CONTRACT CHANGE ORDER NO. 240
SHEET 2 OF 14

MARK	DATE	DESCRIPTIONS	BY	CH'D	CCO#
2	04/05/12	SUSPENSION SYSTEM SHIMS	GB	MN	240
1	04/16/07	CABLE SYSTEM	GB	DT	37

SAN FRANCISCO OAKLAND BAY BRIDGE
EAST SPAN SEISMIC SAFETY PROJECT
SELF-ANCHORED SUSPENSION BRIDGE
(SUPERSTRUCTURE & TOWER)

SUSPENDER BRACKET DETAILS NO. 2

SUSPENDER BRACKET DETAILS NO. 3

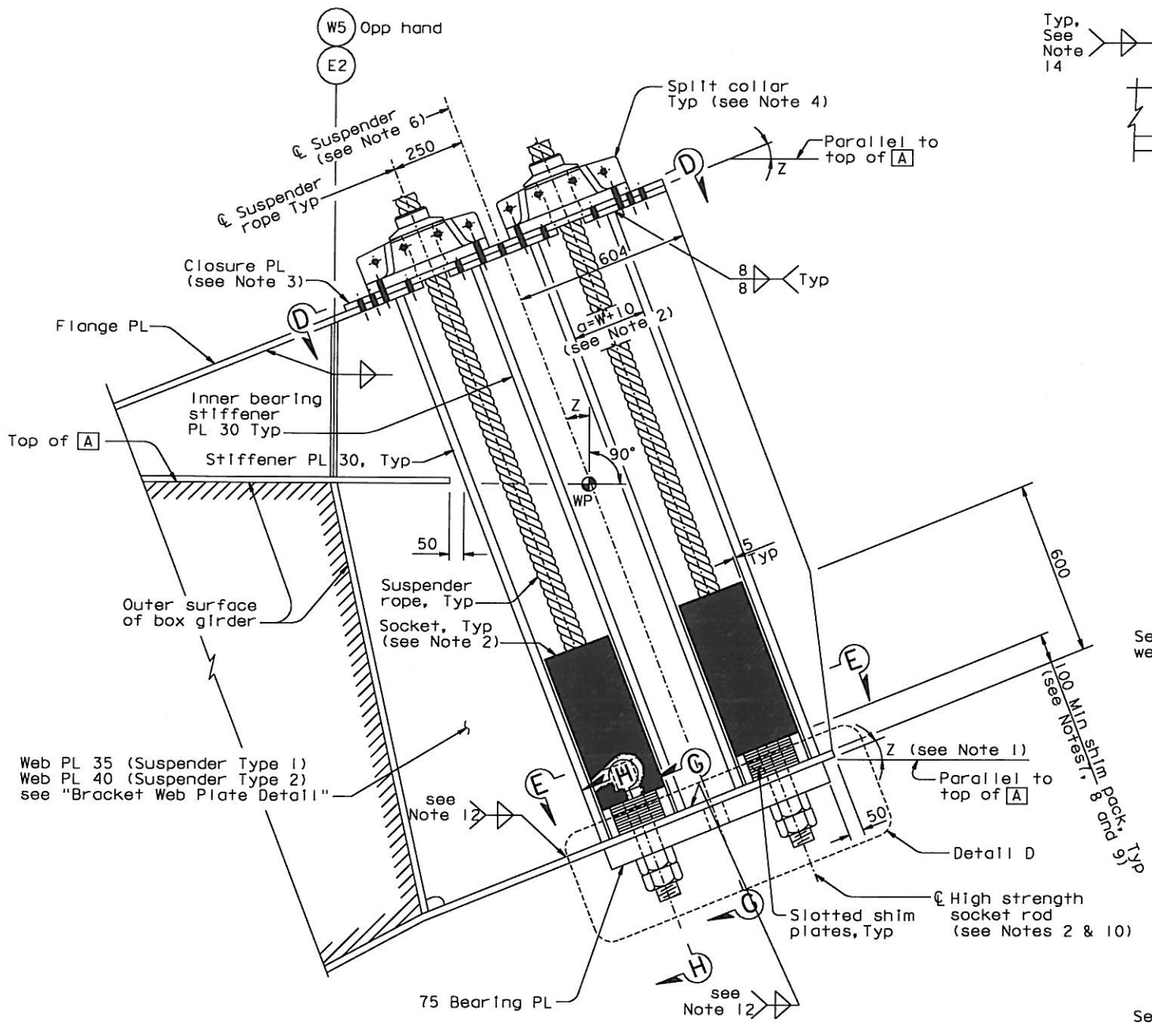
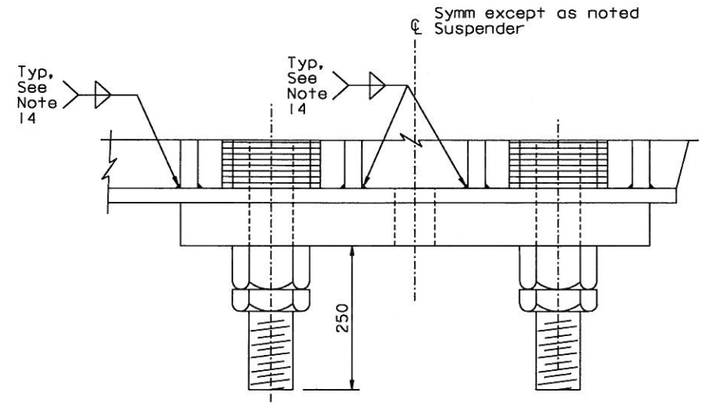
MARK	DATE	DESCRIPTIONS	BY	CH'D	CCO#
2	04/05/12	SUSPENSION SYSTEM SHIMS	GB	MN	240
1	04/16/07	CABLE SYSTEM	GB	DT	37

6. Suspender ℄ varies with bracket location. Cutouts and bolts in flange PL shall be placed with respect to suspender ℄.
7. The Contractor shall provide the specified shim pack thickness for erection adjustment as directed by the Engineer, and to provide future tension adjustment for a LRT. The Contractor may add additional shims as part of his fabrication methods, subject to approval by the Engineer.

8. NOTE DELETED.
9. For shim stack heights, see "Suspender Bracket Details No. 10" sheet.
10. The diameter of holes in bearing plate for socket rods shall be 4 mm greater than the rod diameter.

SLOTTED SHIM DETAIL
1:5

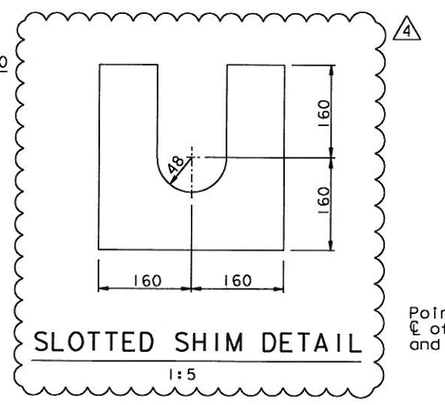
MARK	DATE	DESCRIPTIONS	BY	CH'D	CCO#
4	04/05/12	SUSPENSION SYSTEM SHIMS	GB	MN	240
3	02/20/09	SUSPENDER BRACKETS	GB	DT	104
2	08/15/08	CABLE ELECTRICAL	GB	DT	72
1	04/16/07	CABLE SYSTEM	GB	DT	37

1. Threaded rod may be used for erection. After installation of suspender socket, ends shall be sealed with 90 Dia A307 bolts.
2. For details not shown, see "Suspender Bracket Details No. 1" through "Suspender Bracket Details No. 3" sheets.
3. For split collar details, see "Suspender Bracket Details No. 5" sheet.
4. The Contractor shall consider variation in roadway grade in his details.
5. For cable band details, see "Cable Band Details" and "Cable Handrope Details" sheets.
6. For suspender brackets at PP 108 and PP 110, see "Suspender Bracket Details No. 8" and "Suspender Bracket Details No. 9" sheets.
7. For shim stack heights, see "Suspender Bracket Details No. 10" sheet.

SUSPENDER BRACKET DETAILS NO. 8

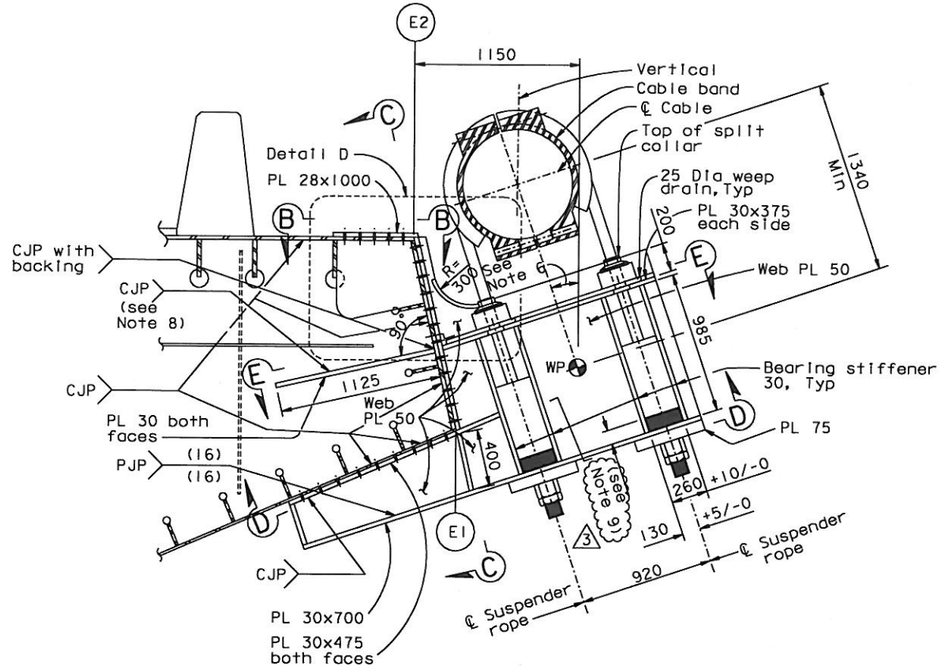
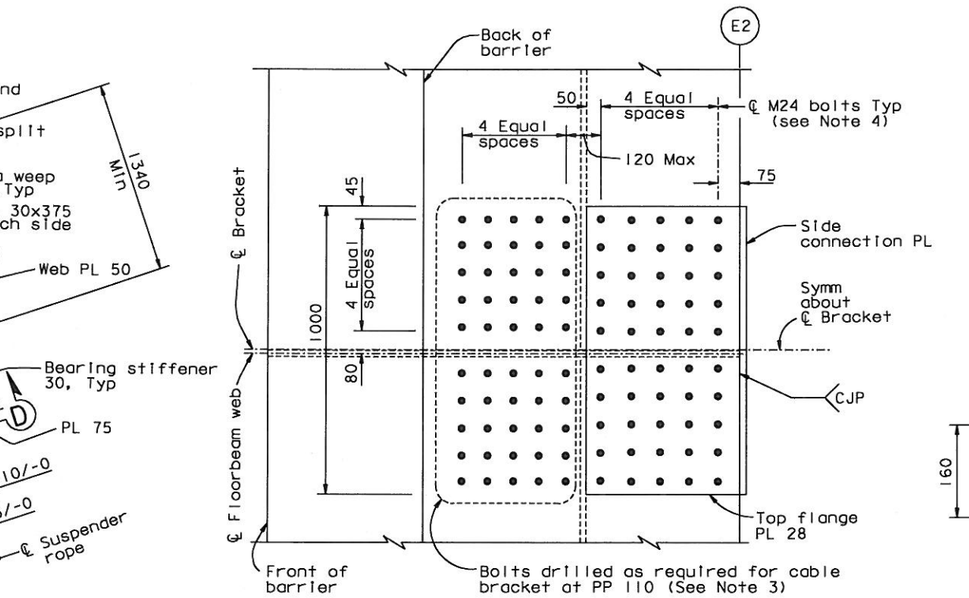
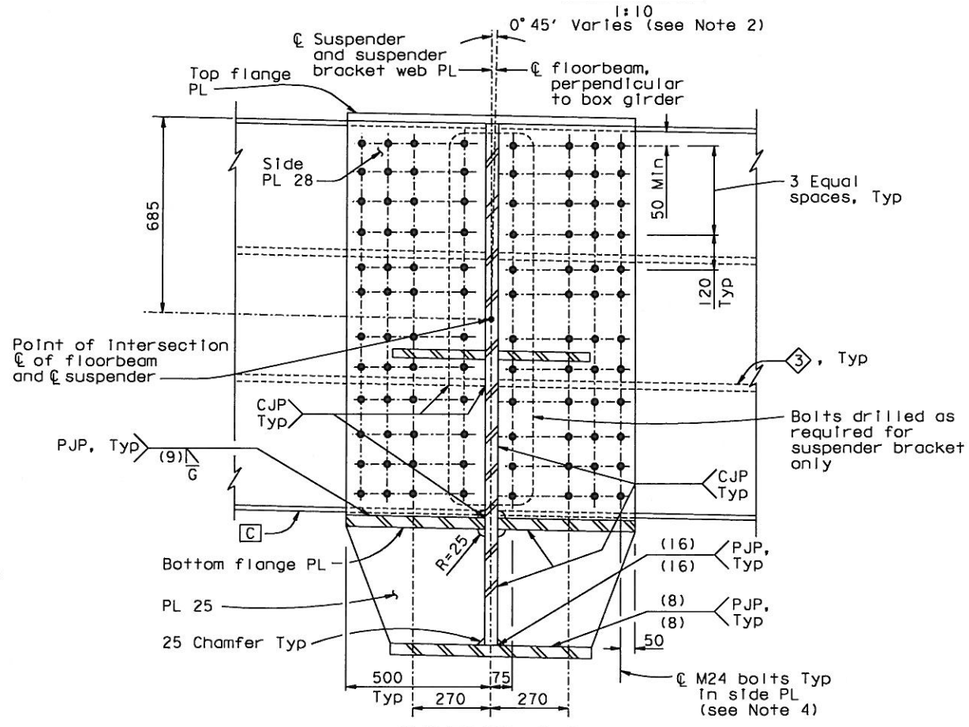
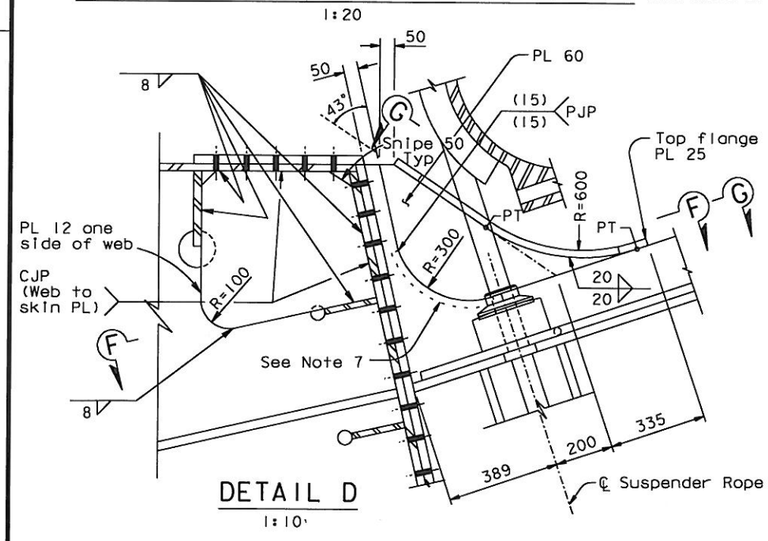
MARK	DATE	DESCRIPTIONS	BY	CH'D	CCO#
3	04/05/12	SUSPENSION SYSTEM SHIMS	GB	MN	240
2	01/05/12	FIELD MODIFICATION OF SUSPENDER BRACKETS	GB	MN	230
1	12/31/09	SUSPENDER BRACKETS	GB	MN	104
0	02/20/09	SUSPENDER BRACKETS	GB	MN	104

1. For details not shown, see "Suspender Bracket Details No. 1" through "Suspender Bracket Details No. 3" sheets.
2. The Contractor shall consider variation in roadway grade in his details.
3. The Contractor shall provide shop drawings for two suspender brackets at PP 110 ("E" line and "W" line). The Contractor shall fabricate and install a suspender bracket at PP 110 ("E" line and "W" line).
4. Bolt spacings shall match cable bracket details, see "Cable Bracket Details" sheets.
5. For View D-D, Section E-E and F-F, see "Suspender Bracket Details No. 9" sheet.
6. All suspender bracket components shall be fabricated to fit the computed cable profile.
7. Remove curve PL 20x50 from both sides and grind flush.
8. At the Contractor's option, CJP with backing may be used, subject to review and approval of the engineer.
9. For shim stack heights, see "Suspender Bracket Details No. 10" sheet.

WEST DEVIATION SADDLE DETAILS NO. 6

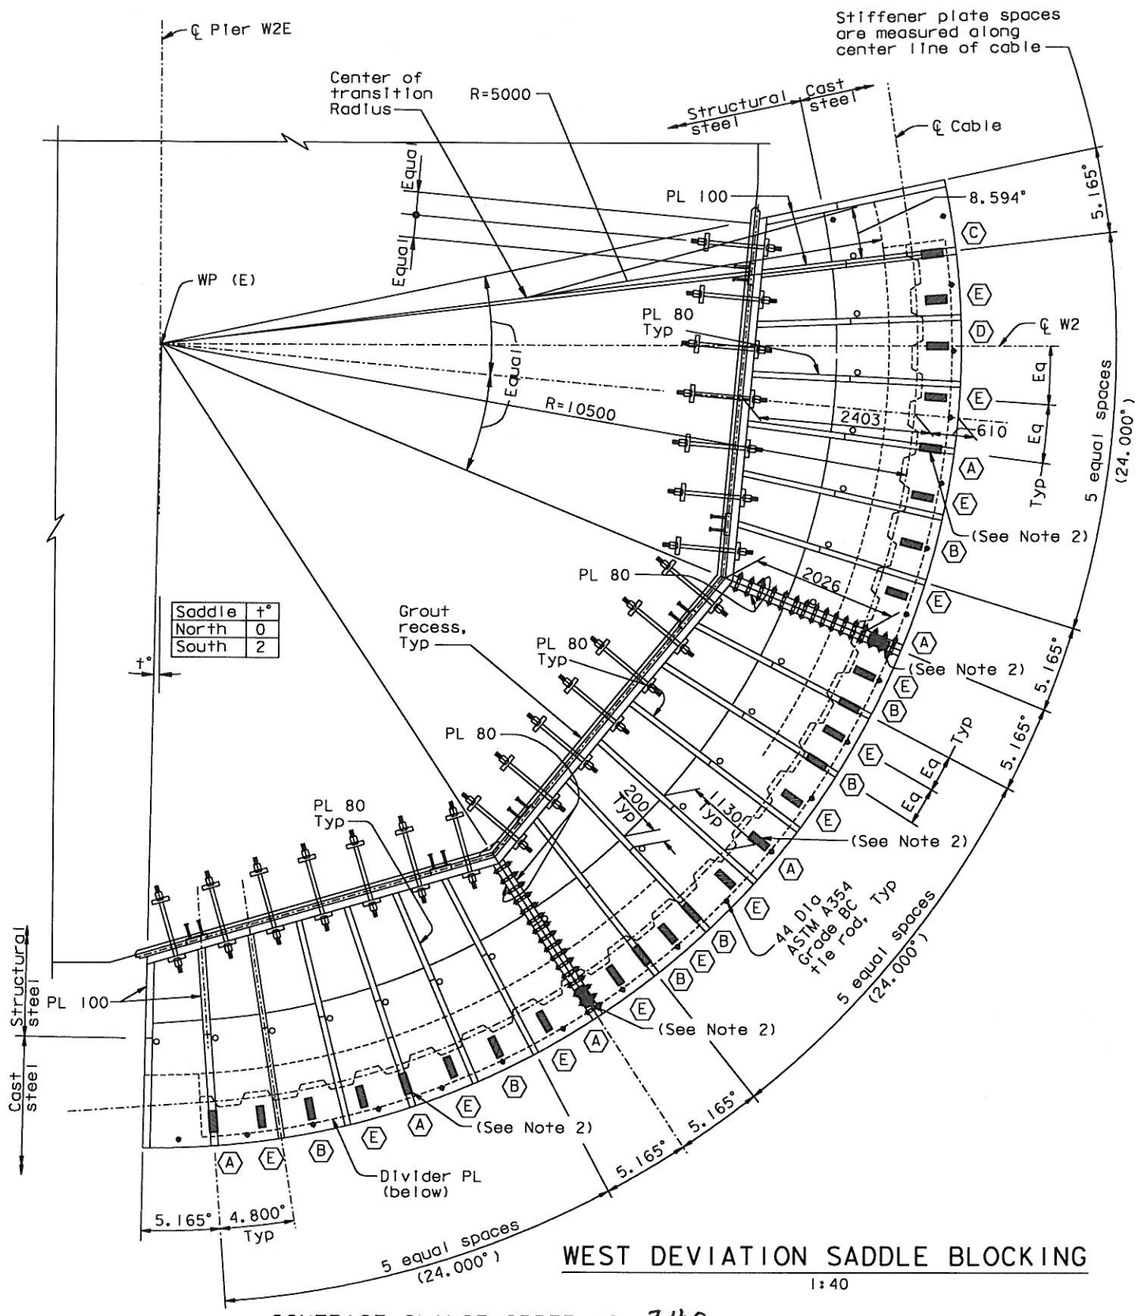
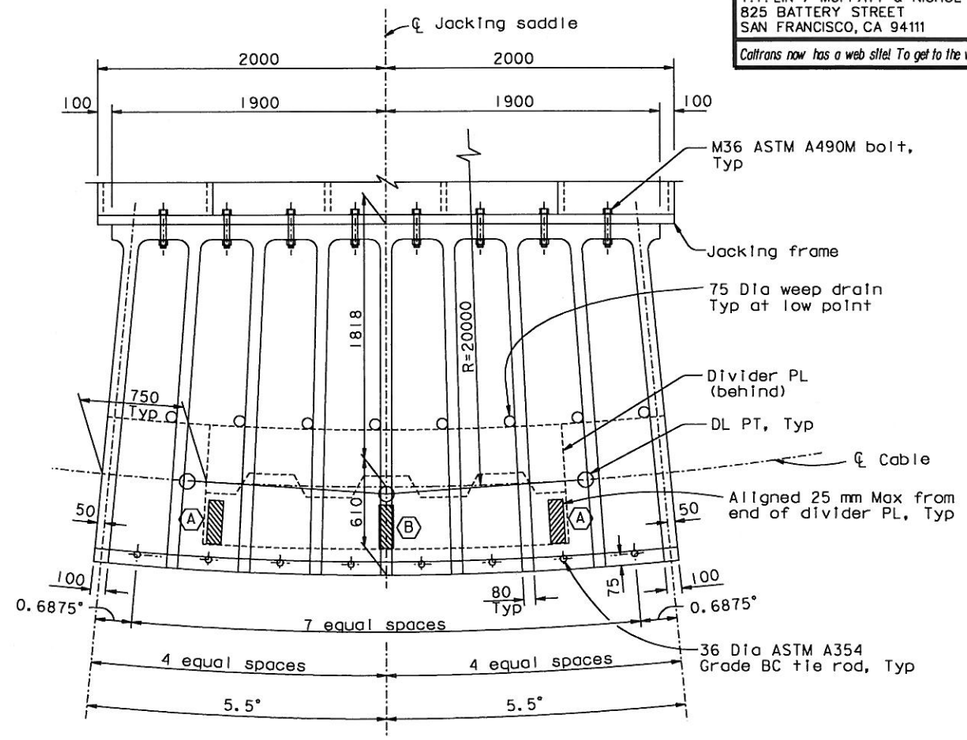
MARK	DATE	DESCRIPTIONS	BY	CH'D	CCO#
0	05/09/12	SADDLE BLOCKING	GB	MN	240

1. For blocking types and details, see "West Deviation Saddle Details No. 7" sheet.
2. Blocking at these locations shall straddle the as-built divider plate radial joint.

WEST DEVIATION SADDLE DETAILS NO. 7

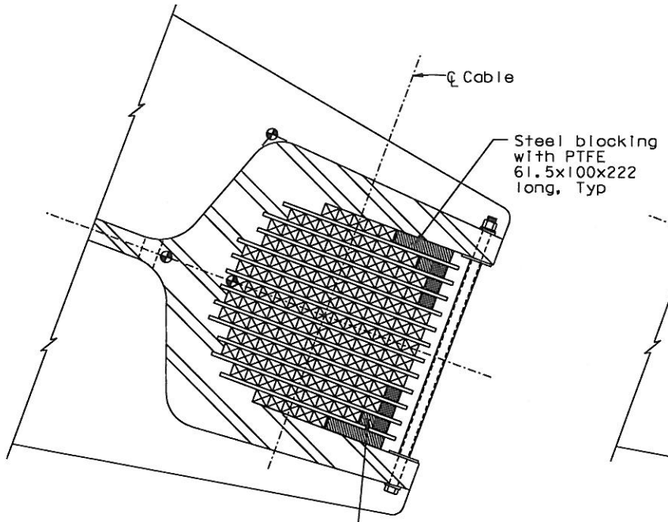
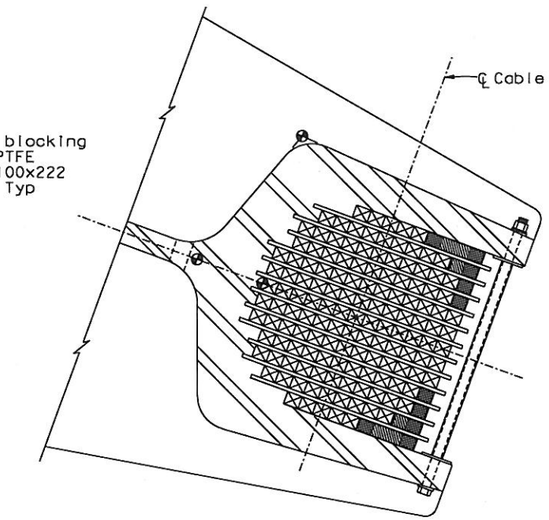
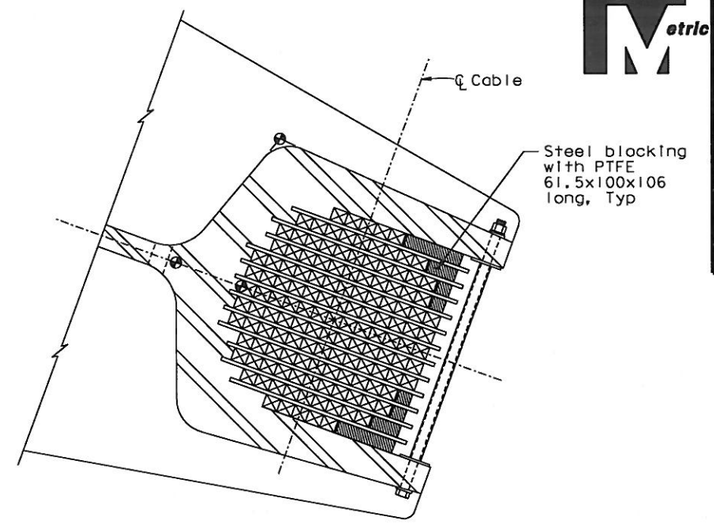
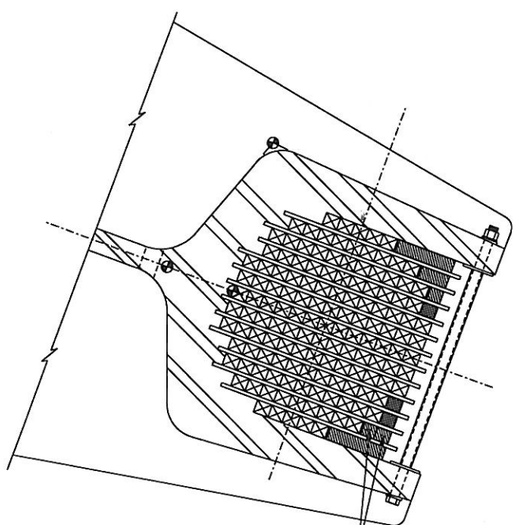
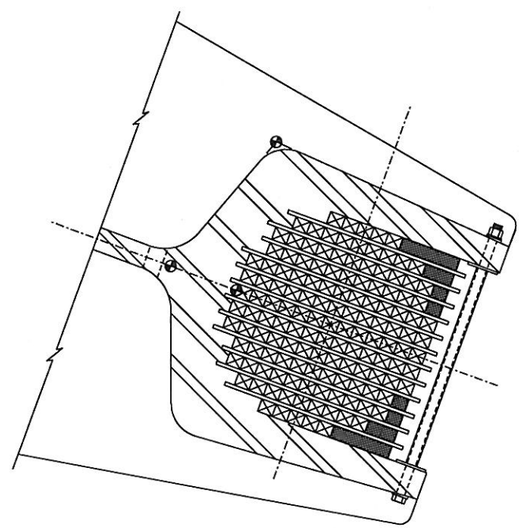
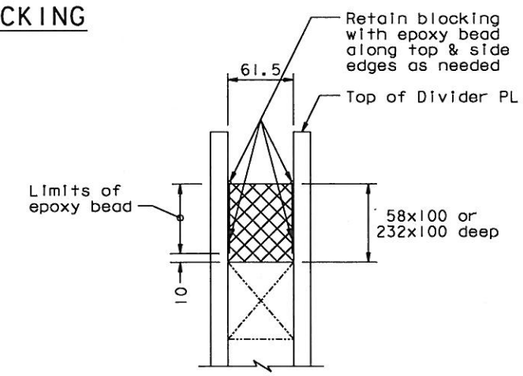
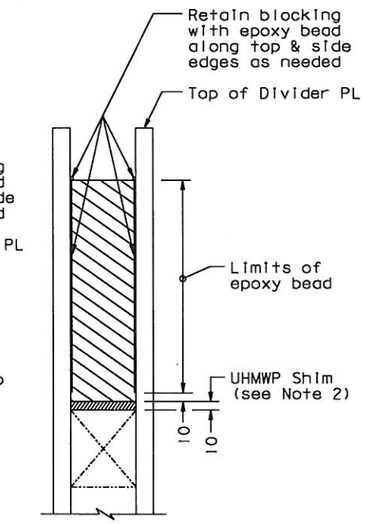
MARK	DATE	DESCRIPTIONS	BY	CH'D	CCO#
0	05/07/12	SADDLE BLOCKING	GB	MN	240

1. Steel blocking fabricated for Tower saddle shall be used for West deviation and jacking saddles.
2. At the Contractor's option, hardwood shims and blocking may be used in lieu of UHMWP.
3. The completed blocking at each location is fabricated to fit tightly. Should tight fit not be achieved, the Contractor shall inform the Engineer for evaluation.
